TOP DRIVE
PRODUCT BULLETINS

CANRIG TD PRODUCT BULLETIN MANUAL

CANRIG DRILLING TECHNOLOGY LTD

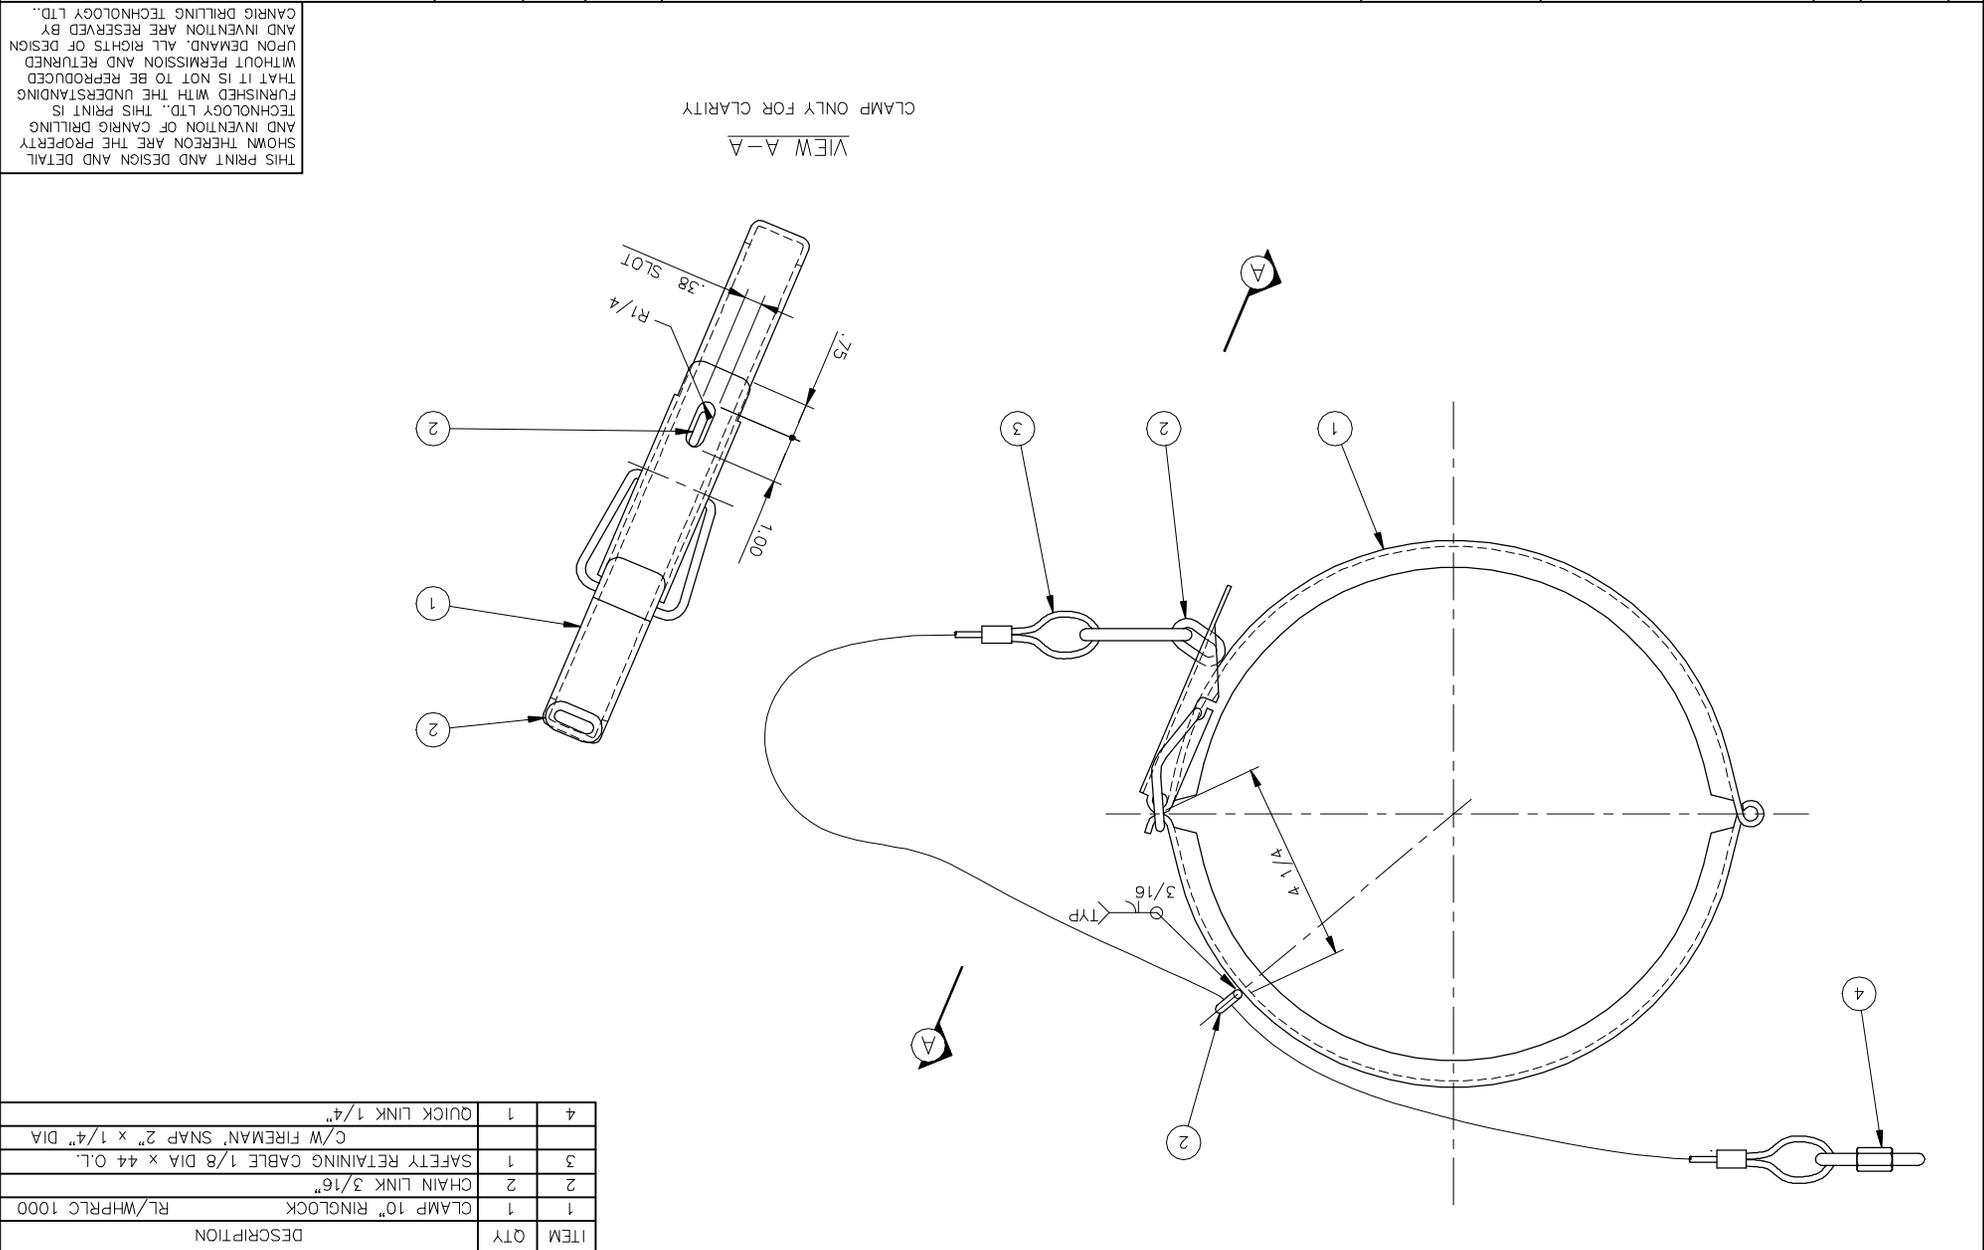
1. The air duct quick connect clamp rings have normally been safety wired to prevent inadvertent opening and falling. A new safety cable arrangement has been developed for improved retention to the clamp- See attached Assembly No.C-3-787-15-0 or C-3-696-16-0. New clamp and safety cables are being shipped to each of the subject units.
2. While awaiting delivery of the new style clamp, please ensure that the quick connect clamp on the air duct is safety wired.
3. A safety cable should also be used to retain the air duct to the top drive unit. See attached Assembly Drawing No. C-2-787-01-3 or C-2-696-01-3.
4. **It is important that both the duct and clamp ring be retained for safety.**

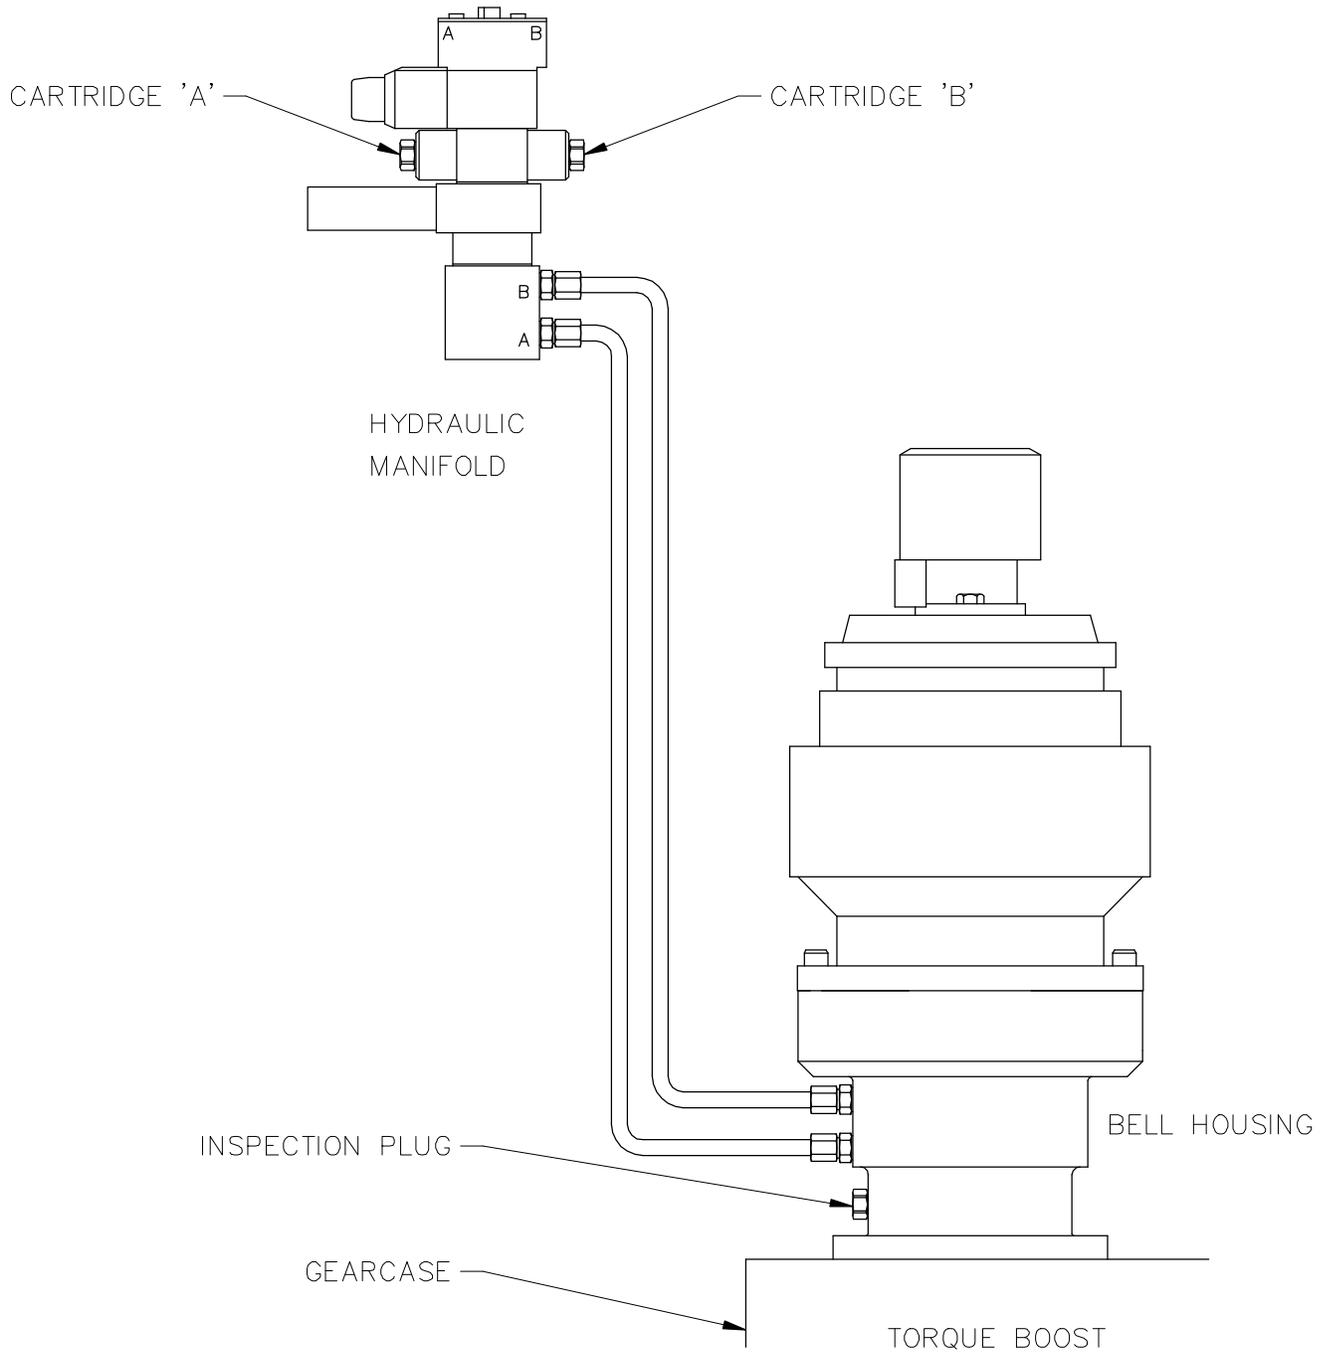
- RECOMMENDATION:**
1. All top drive units with a dual pilot-to-open check valve on the Torque Boost clutch hydraulic valve bank should be changed to a single pilot-to-open check valve on the disengage port of the Torque Boost valve bank. For field modifications, Canrig will supply a plug (part # H13-1026-010) to replace the existing check valve cartridge. Upon receipt of the plug do the following action:
 - a) Confirm that the top drive is plumbed according to Fig.1 attached. The lower port of the valve bank should be connected to the lower port of the torque boost bell housing.
 - b) Remove the check valve cartridge identified as cartridge "B" on Fig. 1.
 - c) Replace with the new plug supplied (part # H13-1026-010).

2. Until the pilot-to-open check valve has been modified avoid using the Torque Boost unless absolutely necessary. If it is absolutely necessary for a connection, and before the modification is completed, use the following procedure:
 - a) Engage the clutch.
 - b) Cycle rapidly between make-up and break-out several times before applying full torque. This will help to ensure full clutch engagement when torquing.

EXISTING SECTION 2

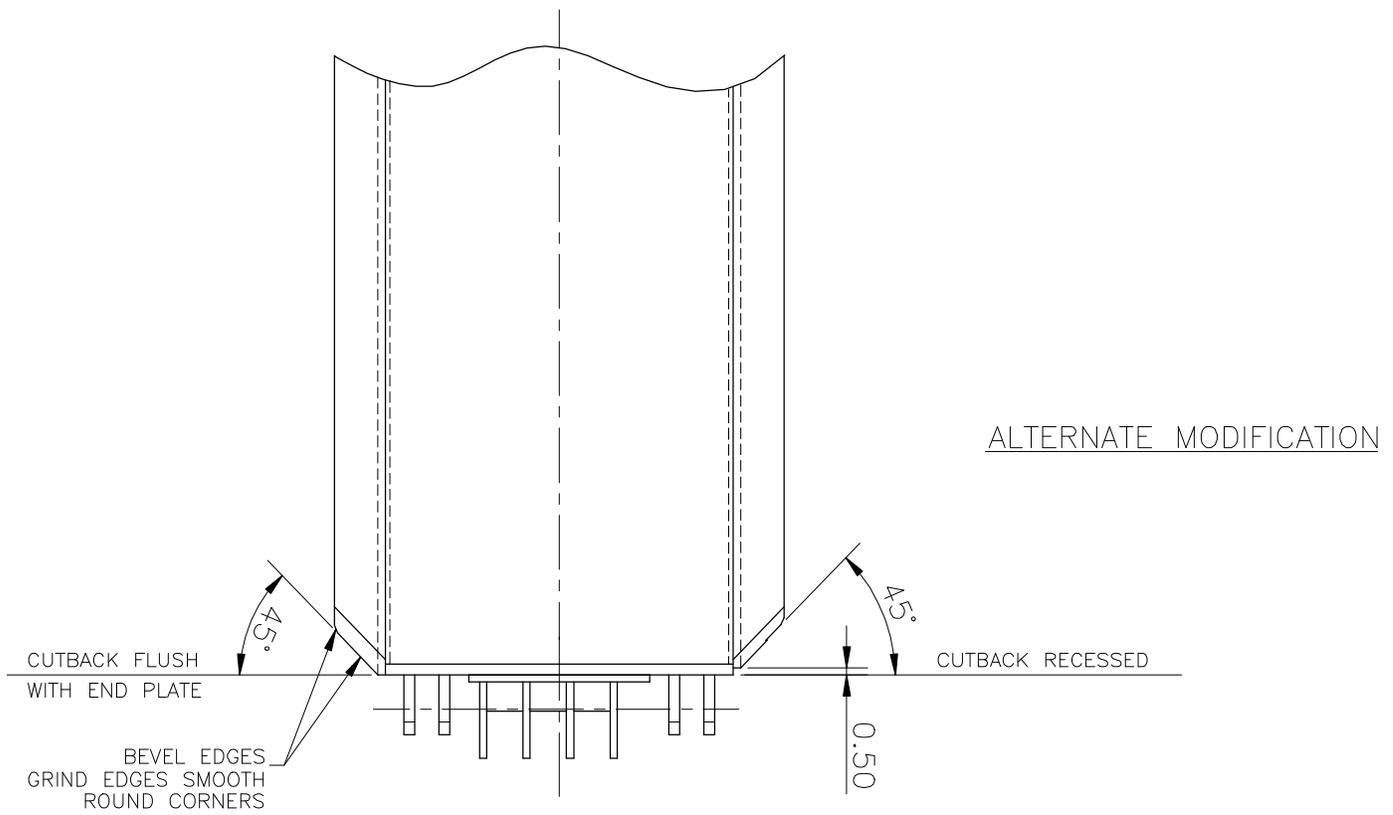
1. The blower needs to be further protected with the addition of a deflector plate which is welded to the top drive guard. The deflector plate should be constructed as shown in Fig.1. Ensure that the edges shown are well rounded to prevent tugger lines from getting caught on it.
2. Cut away the perforated plate in the area shown in Fig.2. Replace the cut away piece with $\frac{1}{4}$ " thick plate or flat bar which measures 2.50" x 6.00 ". This is to allow a stronger weld between the top drive guard and the deflector plate.
3. Weld the deflector plate onto the lower blower guard as shown in Fig.2. The plate should be centered on the pipe and a $\frac{1}{4}$ " fillet weld should be placed all around the plate on both sides.

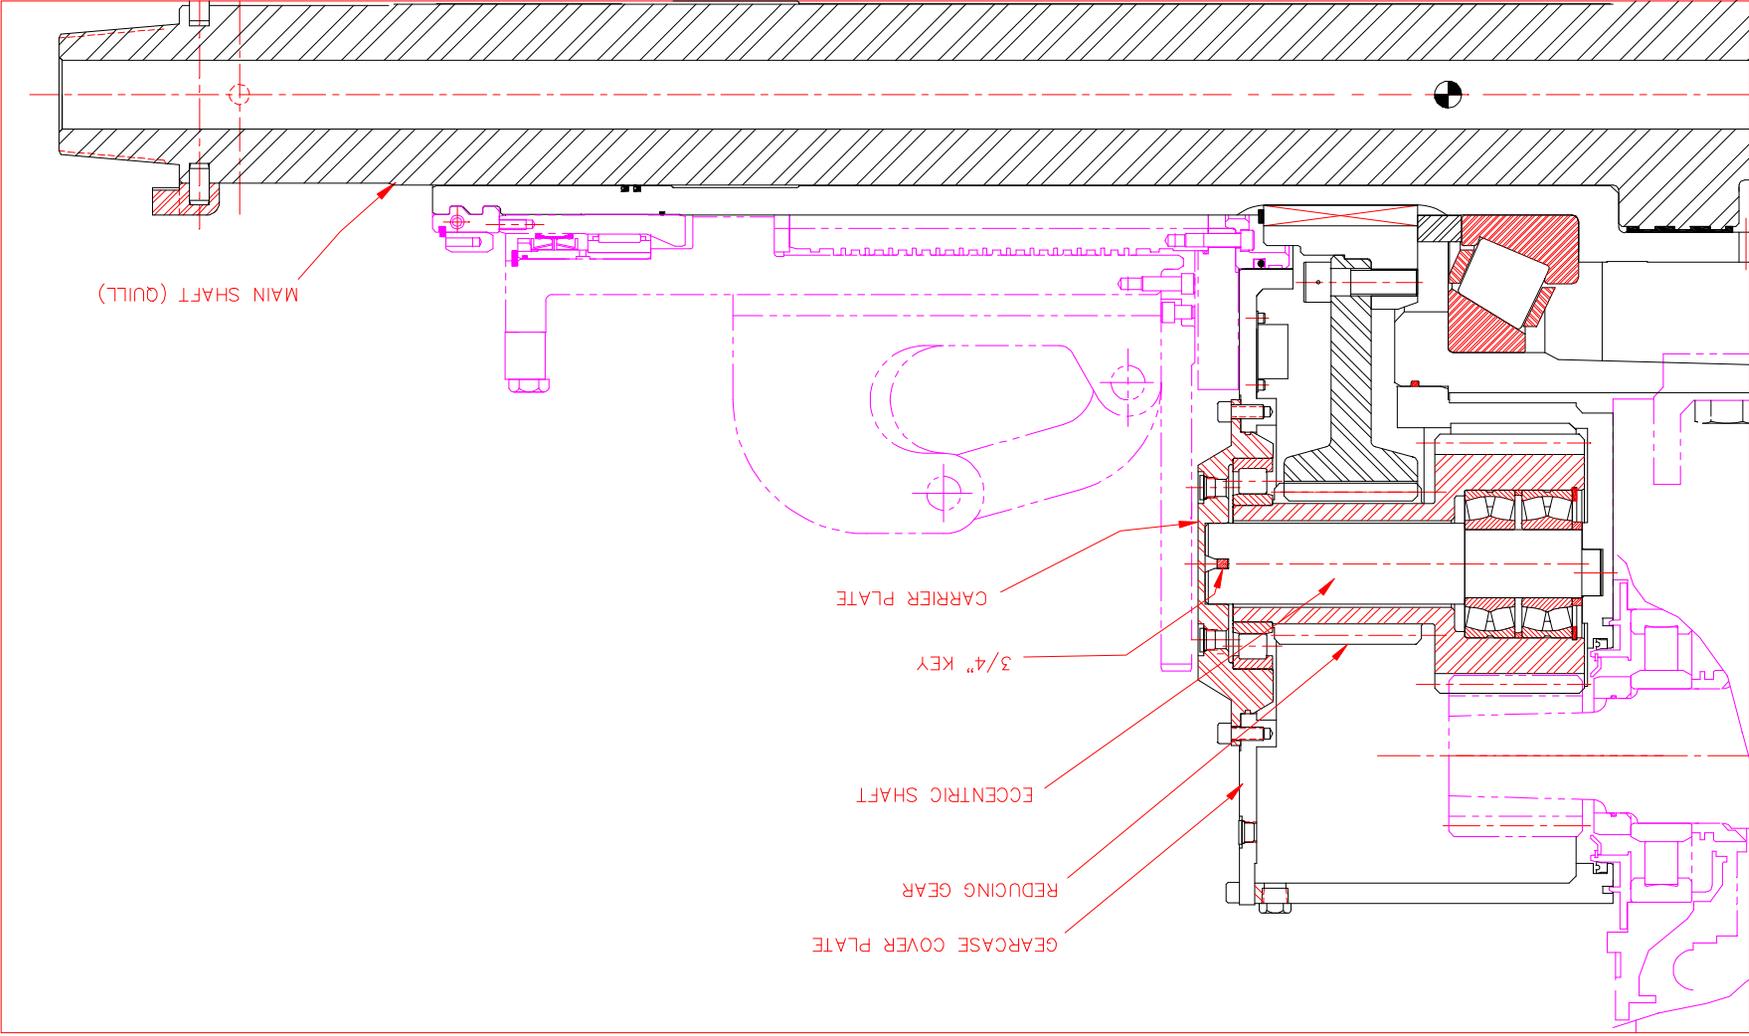
DISCUSSION: It may be possible on some 6.39 and 9.38 ratio 275 Ton Top Drives for the reducing gear eccentric shaft key to break allowing the reducing gear to become mis-aligned. This may lead to a failure of the traction motor shaft. The key is located in the 'reducing gear carrier plate' bolted on the front face of the main gearcase lid (see attached drawing).

RECOMMENDATION: The Carrier Plate and Eccentric Shaft design have been modified to accommodate a $\frac{3}{4}$ " square key instead of the $\frac{3}{8}$ " key. To avoid possible damage to the Top Drive, it is recommended that these components be changed at the rig's earliest convenience. The Carrier Plate (P/N 966-16-0), Eccentric Shaft (P/N 966-12-0) and $\frac{3}{4}$ " key (P/N DT11320) may be supplied at no charge provided that the old parts are returned to Canrig in Magnolia, Texas. Shipping and handling costs will be born by the customer. Alternatively, modification drawings can be supplied by Canrig for the conversion of the existing parts.

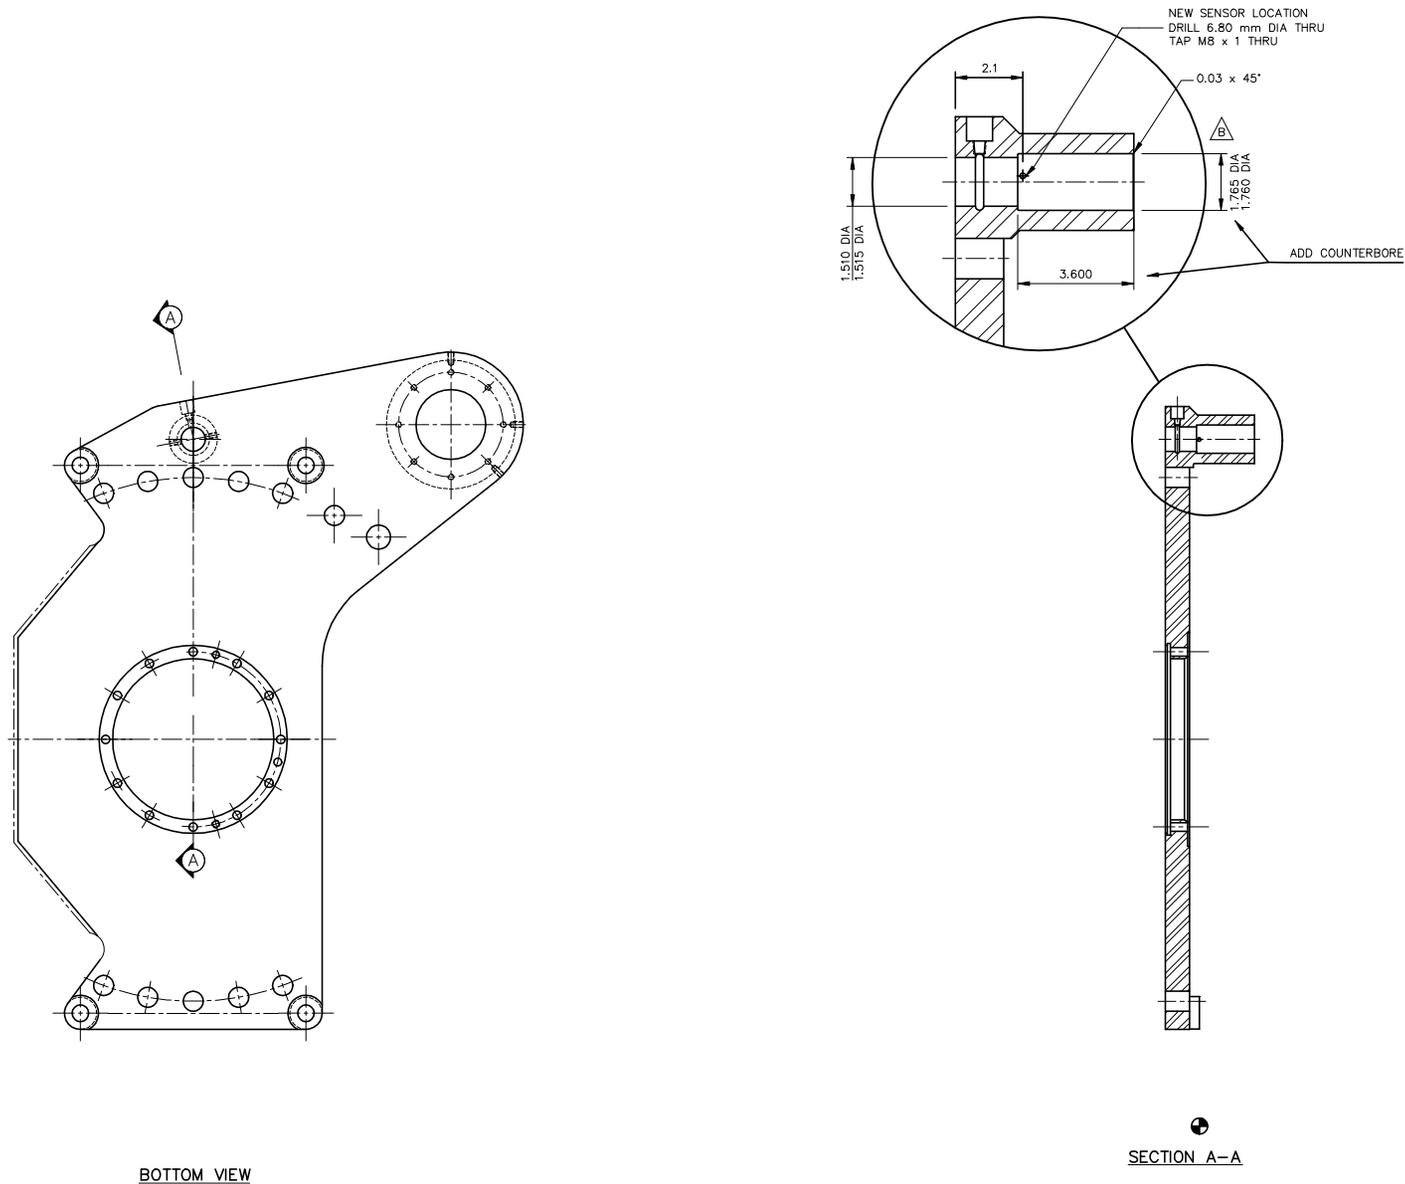
RECOMMENDATION: The full modification should be completed at the earliest opportunity such as a rig move. The rotary manifold plate will have to be removed and the lock pin bore machined to include a shoulder as shown on drawing PB59-D1. A new pin (P/N DT11313) and cylinder (P/N DT11318) should then also be installed.
As a temporary measure until the full modification can be completed, a 1/8" hole can be drilled through the pin and cylinder rod and a roll pin installed to prevent the lock pin from unthreading (see drawing AY10986).

Figure 78.1

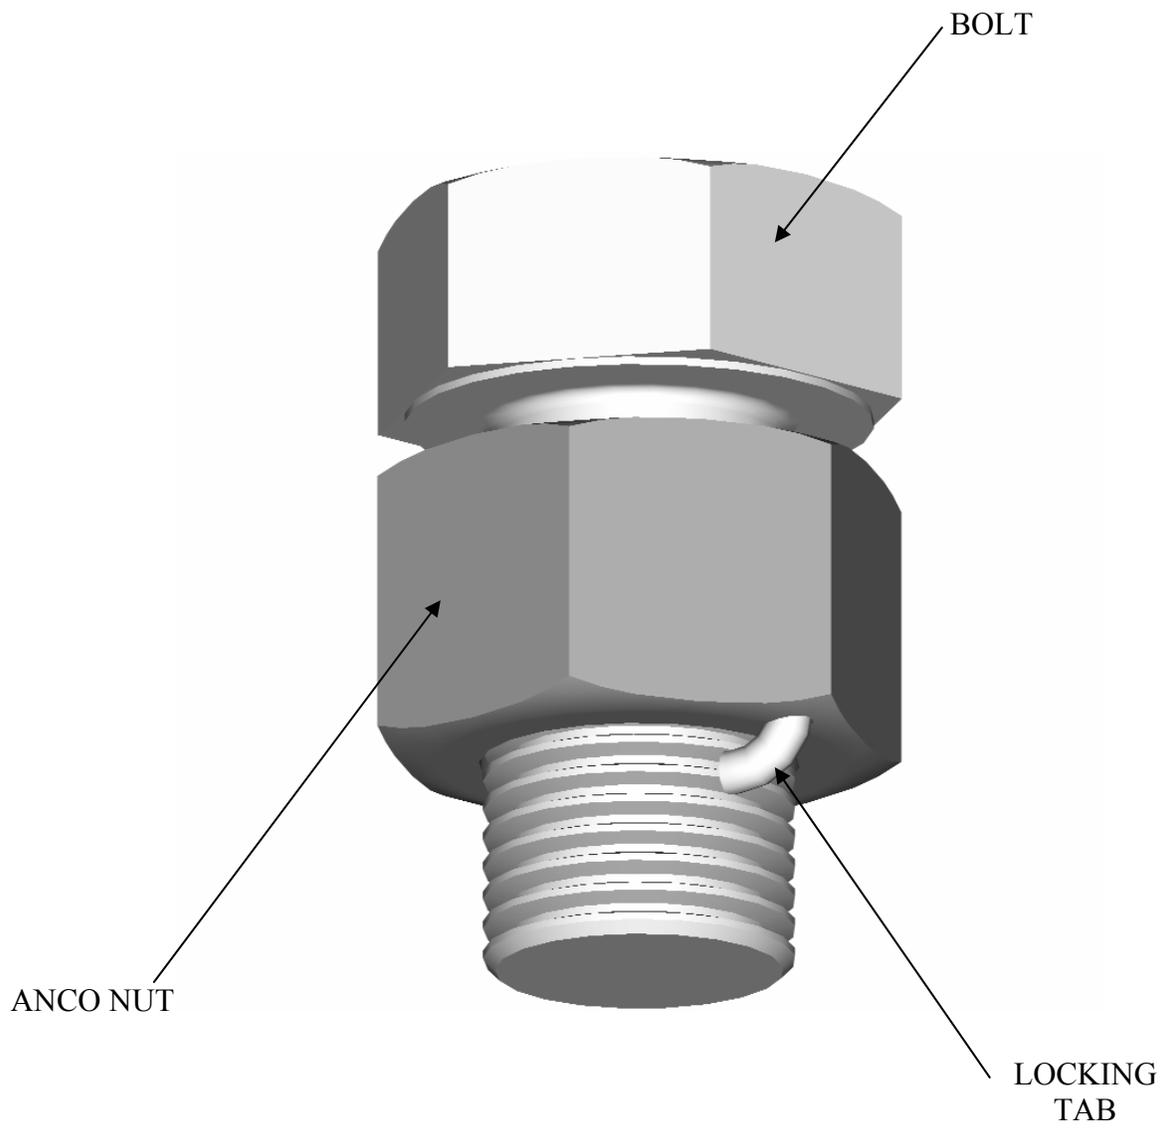
DISCUSSION: Anco lock nuts (See attachment Figure 78.1) are a galvanized construction and the thread profile is made to match with galvanized threads. These threads are not compatible with standard NC threads. These components are currently used on some torque reaction and rig interface assemblies.
